ERCOUPE
SERVICE
BULLETIN

No. **20**

REVISION: A
09/01/2008

SUBJECT: Ailerons—Reinforcement of

FIG. 1 INSTALLATION OF REINFORCEMENT PLATES ON AILERONS AT BALANCE ASSEMBLY MOUNTING POINTS.

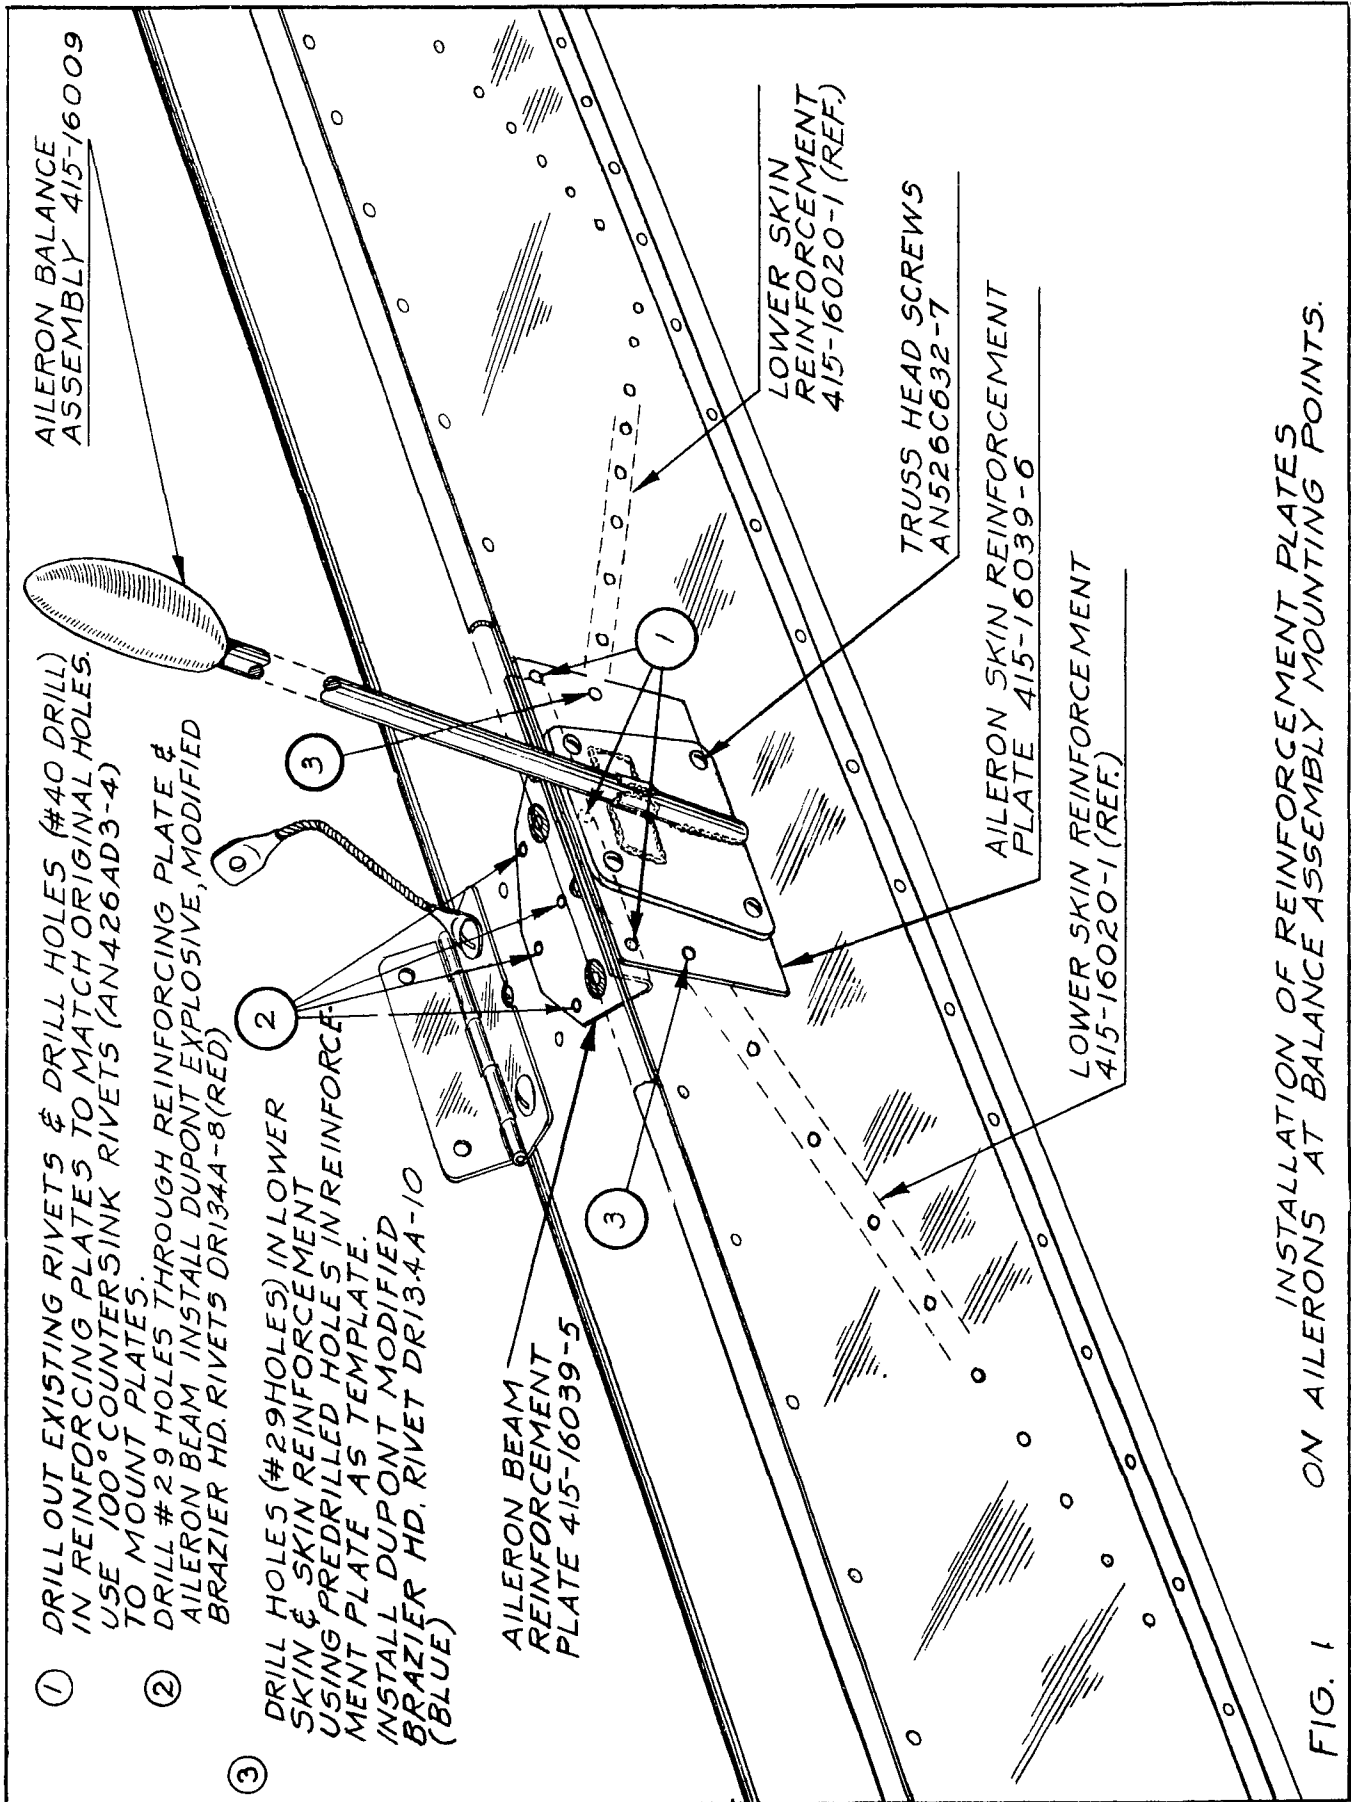
It has been found desirable to increase the strength of the aileron balance weight bracket to beam attachment. As is our policy, the information necessary to incorporate the improvement in delivered Ercoupes is presented. The modification required to obtain the added service life is the addition of two reinforcement plates to each aileron. It is recommended that this bulletin be complied with not later than the next 100 hour inspection except where visual inspection shows the immediate need of a repair.

3. Installation of Aileron Beam and Skin Reinforcement Plates: (415-16039-5) and (415-16039-6) (Ref. Page 4. Fig. 1)

- (3) Drill out the three 100° countersunk rivets from the aileron beam and lower skin seam at the balance assembly attaching flange. See 1 on Figure 1, page 4.

- (5) Insert Cleco buttons or other type fasteners in these three holes. Drill four No. 29 (.136) holes through aileron beam using the beam reinforcement plate as a template. See 2 on Fig. 1, page 3.

- (9) Drill two No. 29 (.136) holes through skin using holes in reinforcement plate as template. See 3 on Fig. 1, page 3.

① DRILL OUT EXISTING RIVETS & DRILL HOLES (#40 DRILL) IN REINFORCING PLATES TO MATCH ORIGINAL HOLES. USE 100° COUNTERSINK RIVETS (AN426AD3-4) TO MOUNT PLATES.

② DRILL #29 HOLES THROUGH REINFORCING PLATE & AILERON BEAM. INSTALL DUPONT EXPLOSIVE, MODIFIED BRAZIER HD. RIVETS DR134A-8 (RED)

③ DRILL HOLES (#29 HOLES) IN LOWER SKIN & SKIN REINFORCEMENT USING PREDRILLED HOLES IN REINFORCEMENT PLATE AS TEMPLATE. INSTALL DUPONT MODIFIED BRAZIER HD. RIVET DR134A-10 (BLUE)
